SUPPLEMENTARY COUNCIL ASSESSMENT REPORT

| Panel Reference | 2016HCC033 |
| DA Number | DA/731/2016 |
| Proposed Development | Retail Premises – Shopping Centre Redevelopment involving construction of new Coles (demolition of existing Coles) and specialty shops |

Figure 1: Scrubby Creek Entry Sketch

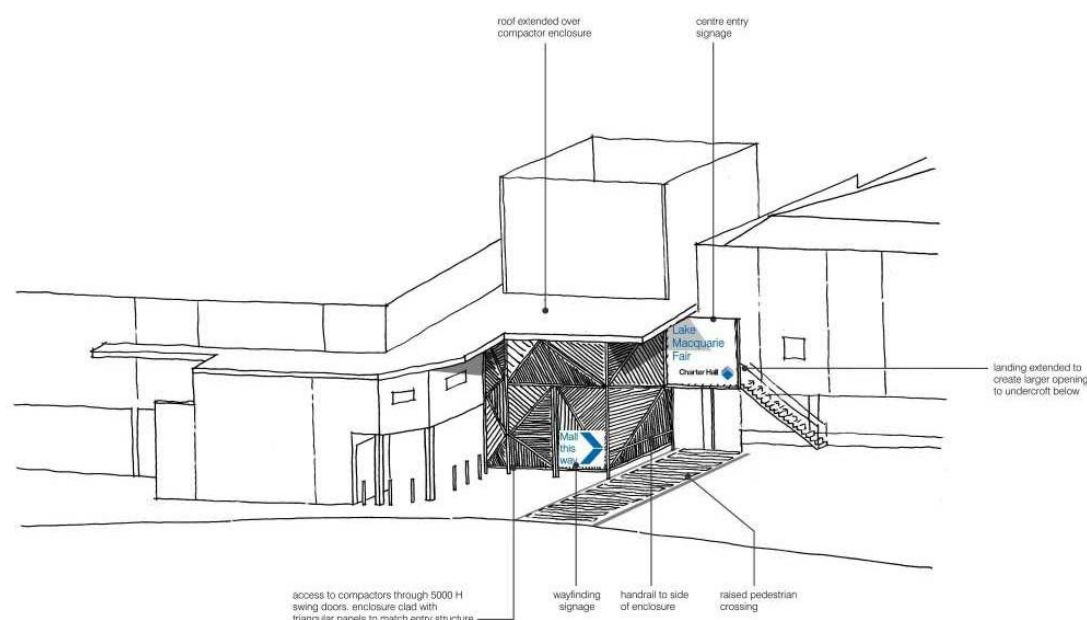
As can be seen in Figure 1 above, the visual screening around the waste compactors has been increased in height from 3.2m to 7.2m as described by the proponent at the determination meeting.

Council considers the additional screening adequately improves the visual appearance of the entry, as it prevents the compactors and chutes from being visible by pedestrians, and would not be easily identifiable as a waste area if the odour can be suitably managed as per the proponents advice at the determination meeting.

However, as covered in further detail in point (iii) below, Council still maintains its concerns regarding the lack of separation provided between the waste area and pedestrian path, due to the level of pedestrian amenity, CPTED concerns (concealment opportunities) and safety (waste vehicle movements). It is considered that while the increased screening is an improvement, it does not fully satisfy the concerns previously raised by Council's Integrated Planning Section and Landscape/Urban Design Architect, or the objectives for the Scrubby Creek entry in the Mount Hutton Town Centre Area Plan.

Despite these concerns, Council considers that the amended waste area screening is consistent with the comments provided by the Panel at the determination meeting.

Figure 2: Loading Dock Sketch

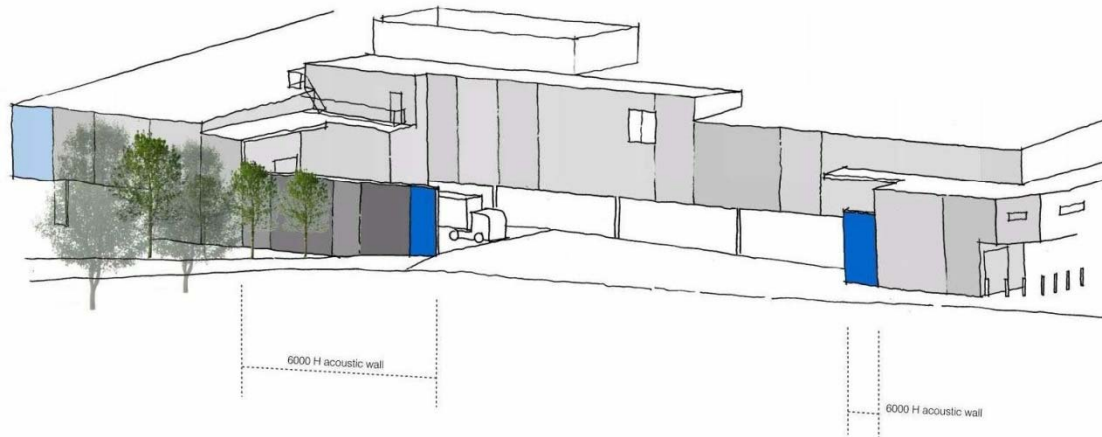
As can be seen from the above sketch, the barriers have been increased in height from 2.2m to 6m and integrated into the external architectural treatment of the shopping centre.

The increased height of the acoustic screens do not present any additional visual impact concerns, nor results in any additional height to the building.

As detailed later in this report, Council has sought independent acoustic advice. The independent review recommended that the barriers be a minimum height of 6m, and extended 5m past refrigeration units located on the front of the trailers (refer to added detail later in this report). The applicant has amended the plans in this regard and Council's Environmental Management Officer is satisfied that the development can achieve the specified noise criteria, subject to conditions.

Council does not have any additional concerns in regarding the increased height of the acoustic barriers, and it is considered that the amended loading dock is consistent with the necessary requirements for acoustic attenuation, and the Panel's comments at the determination meeting.

Figure 3: Pre-Lodgement Plans discussed on 28 October 2014

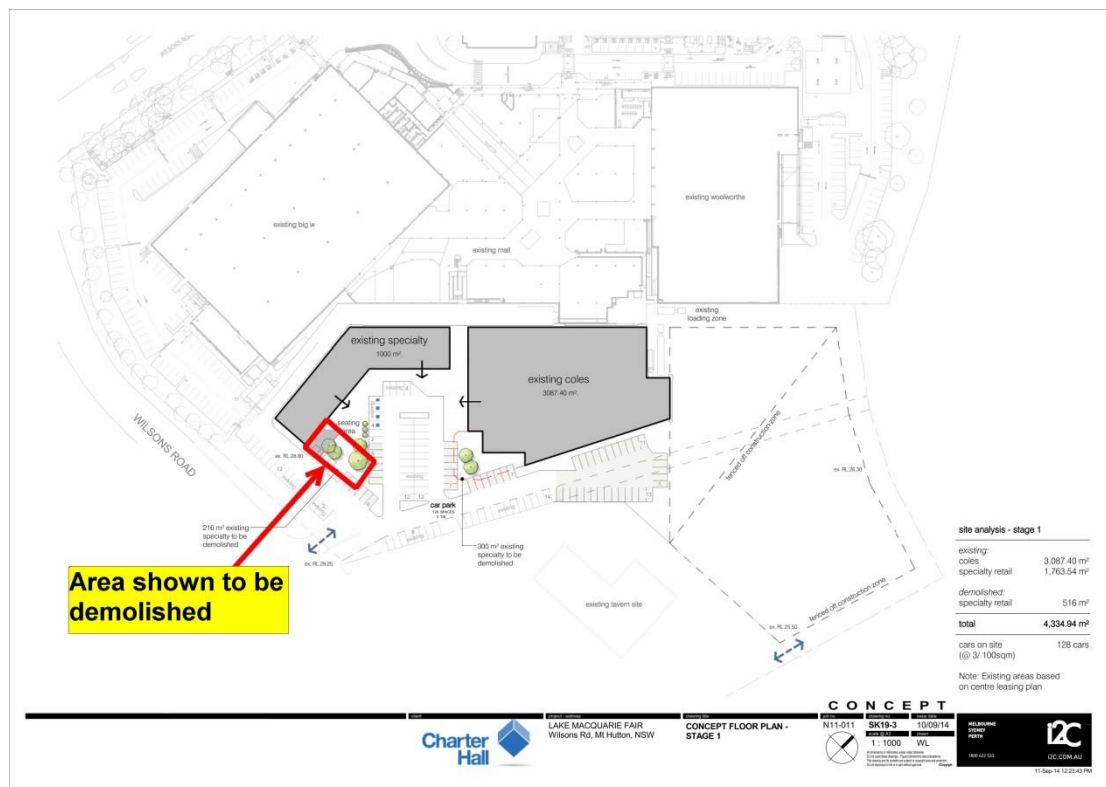
In this regard, Council's preference would be for part of the existing shops to be demolished to allow for a more direct entry and visual link between Wilsons Road and the new shopping centre entry, similar to advice provided to the applicant prior to addition of the Service Station concept plan, and what was proposed in the original plans discussed with Council at the pre-lodgement meeting on 28 October 2014, shown below.

Partial demolition of the existing shops fronting Wilsons Road as shown above would significantly improve the pedestrian amenity and the streetscape appearance, and would be more consistent with the objectives of the Mount Hutton Area Plan.

Council also recommends that improvements to the appearance of this building are justified given the potential for it to be retained long term. In this regard, it is recommended that the retained section facing the street be rendered (or similar) with

suitable architectural treatment, with screening to be provided for plant located on the roof.

These outcomes (partial demolition and façade improvement) will result in a significantly improved streetscape outcome and can be achieved without implications for the rest of the development. A recommended condition is included in this regard requiring partial demolition and upgrade to the existing shops in line with the above plan, with amended details in this regard to be submitted prior to the issue of a Construction Certificate for Stage 3 (Specialty Shops). This condition also requires the demolition to occur prior to the issue of any Occupation Certificate for Stage 3, to ensure that the improvement works are undertaken prior to occupation of the Specialty Shops.

Figure 4: Stage 4 as shown on amended plans

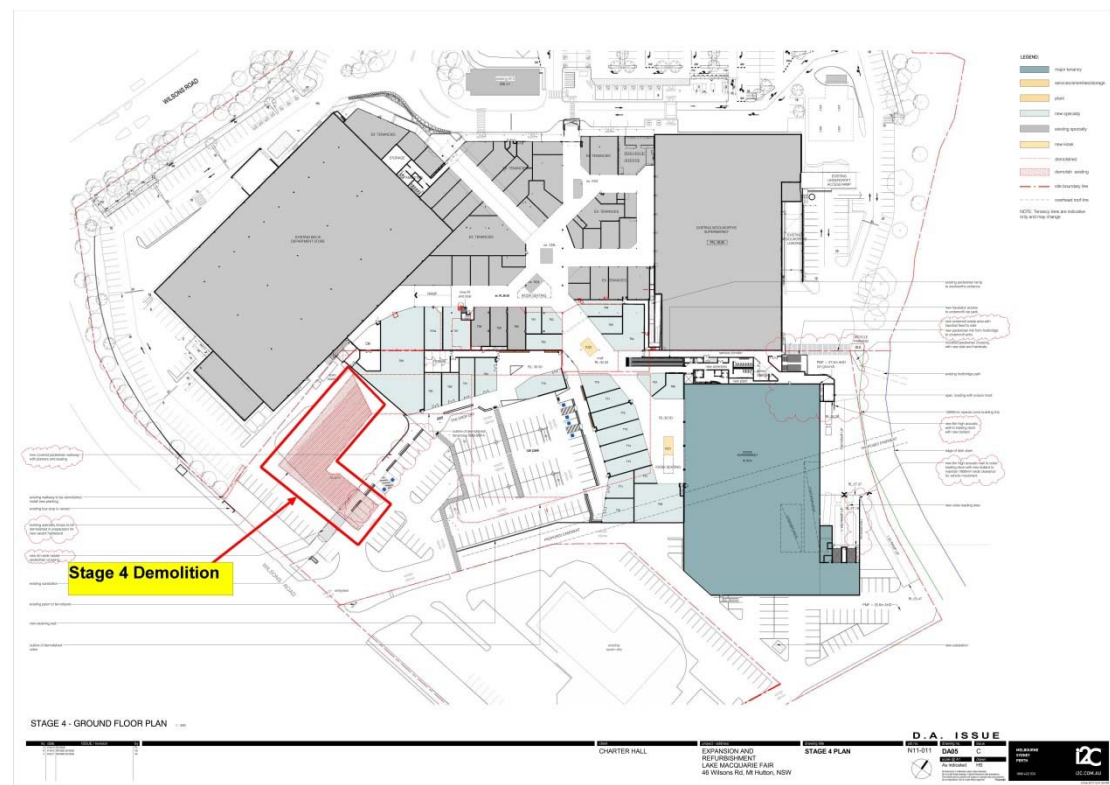
Council has concerns that allowing demolition of the shops fronting Wilsons Road prior to any consent being obtained for replacement development in that location will result in the area being a vacant concrete slab for a significant length of time. This is not considered to be an acceptable outcome from a streetscape and pedestrian amenity perspective.

The applicant has advised that it is intended for a separate application to be lodged for a Service Station in that location as soon as possible after determination of this application. However, there is no certainty regarding the lodgement or determination of any such application.

Given these circumstances, it is considered reasonable in this instance to impose a condition on the demolition proposed by Stage 4, and not permitting any works associated with Stage 4 to be undertaken until such time as a separate application for development in this location is approved, and a construction certificate subsequently issued.

This will allow for the applicant to factor the Stage 4 demolition into their works program, without potentially resulting in the Stage 4 demolition without any future development being approved for that location.
